TECH-NEWS

Handle Bracket Update**October, 2010**

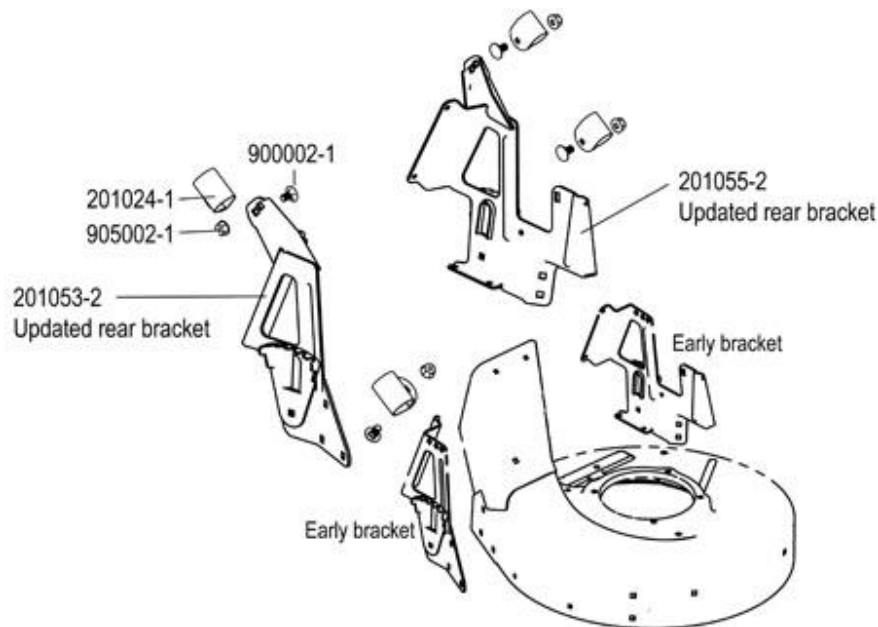
We have received a few complaints about the handle attachment to the mower deck:

- The handle tubes are "flexing" too much
- A few clamps and rear brackets have broken

To address these complaints we have redesigned the rear handle brackets per the illustration. The new design separates the tube clamps (201024-1) and contributes to an overall stronger attachment of the handle to the mower.

- 4ea 201024-1 Handle Clamp
- 1ea 201053-2 Bracket, Right Rear Assembly
- 1ea 201055-2 Bracket, Left Rear Assembly
- 4ea 900002-1 Carriage Bolt, M8x16
- 4ea 905002-1 Flange Nut Locking-M8
